# **SERVICE BULLETIN**MAINTENANCE OF WAY EQUIPMENT

<b>DATE</b> : 04-2020				<b>BULLETIN NO:</b> 20-004		
TITLE: Trans	mission To	orque Lug Fastener Upgra	de			
RATING:		<b>DIRECTIVE</b> (Action Is Required)	X	ALERT (Potential Problem)		
		INFORMATION (Action Is Optional)		PRODUCT IMPROVEMENT (Enhance Product)		
PRODUCT SI	ERIES / MO	ODEL: MARK IV Produc Drive Transmissi		itch Tampers with Durst or Cushman		
SERIAL NO:	N/A					
SUMMARY:	Harsco Rail has become aware that the lock nuts on the bolts that secure the transmission torque link have the potential of loosening until they fall off. When this happens, the torque link mounting bolts can work out of the torque link mounting resulting in the transmission torque link disengaging from the machine frame. Follow the instructions in this Service Bulletin to replace the existing fasteners with new fasteners included in Torque Link Bolts Conversion Kit #5110548.					
OPERATION	of the tord	que link mounting during ovn and strike the railroad and track structure, mach	operation I cross ti	torque link loosen and then work out or track travel, the transmission may es which may cause damage to the ilment and possible personal injury to

## FIGURE-1 TORQUE LINK ASSEMBLY

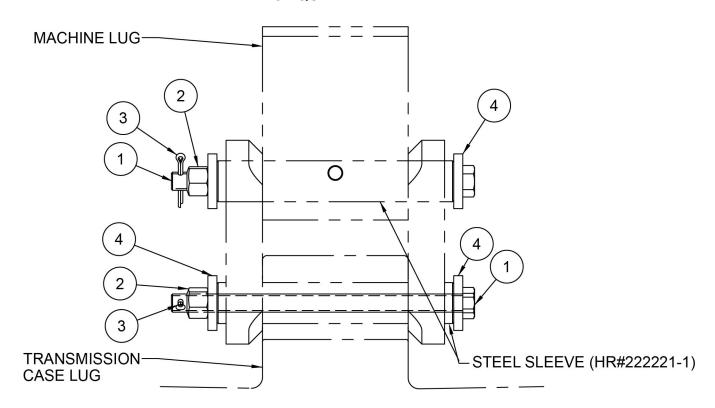
- 1. Make sure all machine work components are in the stored position and locks are engaged.
- 2. Make sure the machine is shut down, parking brakes are applied and battery switch is turned off. Chock the machine wheels.
- 3. Inspect the two bolts that secure the torque links to the frame lug and transmission lug. If the bolts do not have cotter pins on the lock nut ends, the bolts will need to be replaced.
- 4. Order one Torque Link Bolts Conversion Kit #5110548 for each transmission torque link mounting that is being reworked. For a MARK IV, two (2) total kits would be required per machine.

ACTION:	Follow the instructions in this Service Bulletin to inspect the transmission torque link bolts and replace the existing fasteners with new fasteners included in Harsco Rail Conversion Kit #5110548. Order one Torque Link Bolts Conversion Kit #5110548 for each transmission torque link mounting that is being reworked For a MARK IV, two (2) total kits would be required per machine.					
CONTACT:	Harsco Rail Service Department

- 1. Secure the front of the transmission using jack stands, blocks, etc.
- 2. Remove items (1), (2) and (4) and discard.
- 3. Install new cap screw (1), new hex lock nut (2), new washers (4) and existing steel sleeve, Harsco Rail #222221-1.
- 4. Secure hex lock nut (2) and install cotter pin (3). Bend both legs of the cotter pin to secure it in place.
- 5. Remove items (1) and (2) and discard.
- 6. Install new cap screw (1), new hex lock nut (2) and new washers (4).
- 7. Secure hex lock nut (2) and install cotter pin (3). Bend both legs of the cotter pin to secure it in place.
